Sent: 16/03/2020 8:51:13 AM
Subject: Further submission to DA 26 Ralston Road, Palm Beach 2020/0096
Attachments: Letter of Objection 26 Ralston FINAL.pdf;

RE: DA 2020/0096- Proposed dwellings on land at 26 Ralston Road, Palm Beach.

Figure 4 Extract of the shadow diagrams in March/September at 9am, 10am, 11am and 12pm at which time overshadowing is improved when compared to June, showing shadow onto our clients' site until midday.

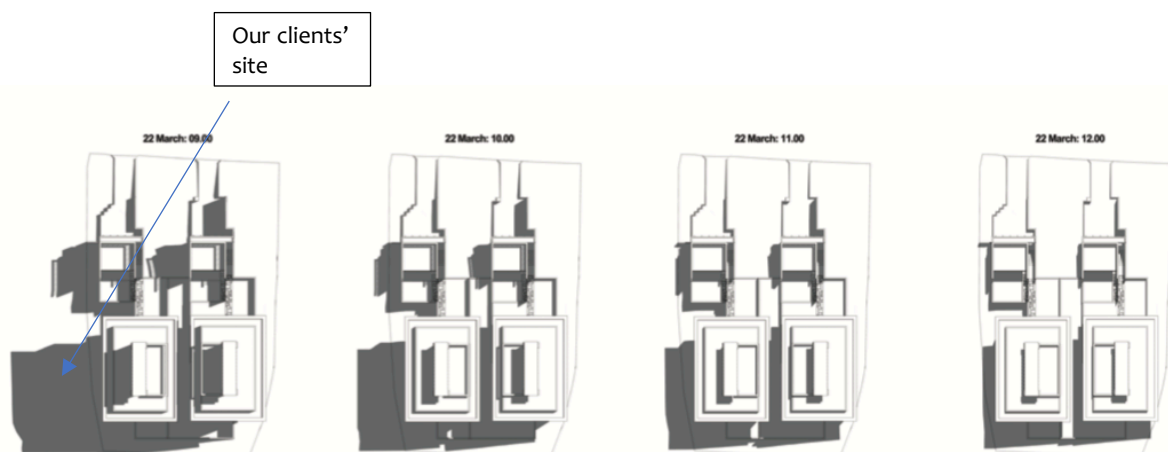
The absence of any boundaries or the outline of surrounding structures on the submitted shadow diagrams renders them useless in the assessment of the private open spaces of our clients' site. In particular we note that the private open space of our clients' property is located in the south eastern corner, immediately adjacent to the subject site. The shadow diagrams indicate shadows will be thrown into this corner of their garden. This is a highly used area of our clients' property for outdoor dining, relaxation and entertaining.

The site analysis did not make comment (either diagrammatically or in written explanation) on the layout or use of any of the adjoining sites. The SEE states that "*The proposed shadows do not adversely impact on neighbouring dwellings or the private outdoor spaces of adjacent dwellings.*". Given the absence of the surrounding dwellings on the shadow diagrams we challenge this statement which

has been made as it appears that the private open space and parts of the dwelling are heavily overshadowed even in the equinox. This would indicate that the development of lot 4 is an overdevelopment of the site.

Further to the above, our clients site sits at a much lower level than the subject site and without surveyed ground levels we would question the accuracy of the submitted shadow diagrams. Our clients request that shadow diagrams be certified.

Figure 8 showing extract of landscape plan beside our clients' site with areas of proposed landscaping over the common boundary.

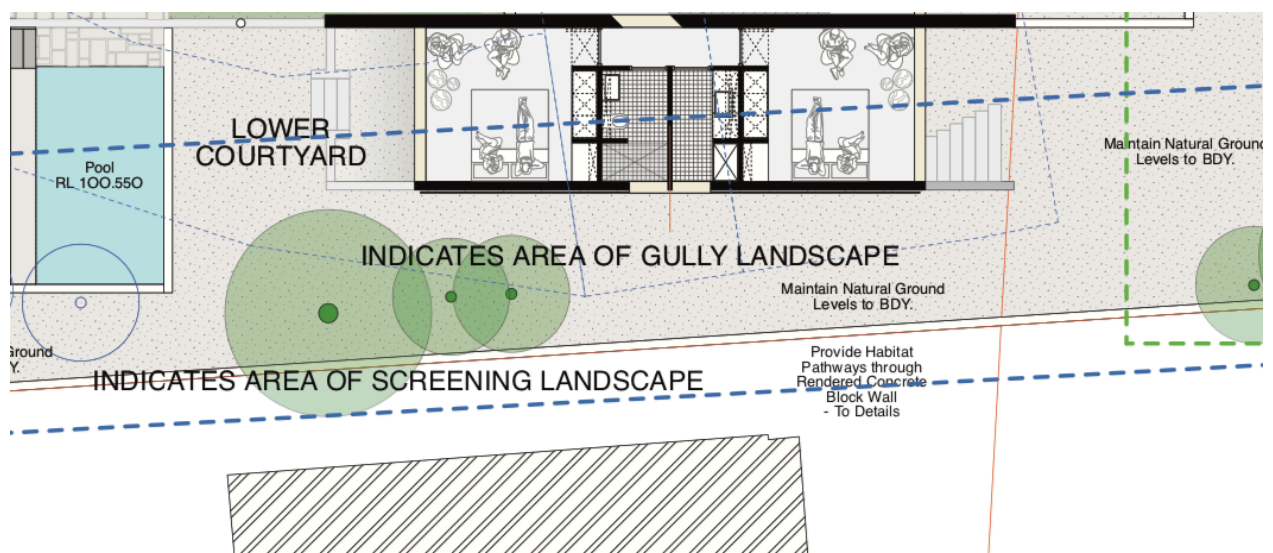
The landscape plan is unsatisfactory for the reasons highlighted below. The elevated structures such as the pool terraces cannot be satisfactorily screened at the height proposed to either soften the built form forward of the dwellings or to provide visual screening for neighbours.

- the landscaping plan does not clearly indicate the trees to be removed (this is only referenced by blue circles which relate to a notation on one other plan in the set.)
- there is an absence of finished and proposed RLs on the plans. References to natural ground levels being maintained and natural grades to street must be confirmed by RLs on the plans.
- as shown below, the landscape plan is schematic and relies on mark ups such as "*indicates areas of screening landscape*", immediately adjacent to our clients' boundary and private area of open space. Such mark ups clearly overlap the boundaries. Our clients have no certainty as to what is proposed beside their boundary in terms of landscape.
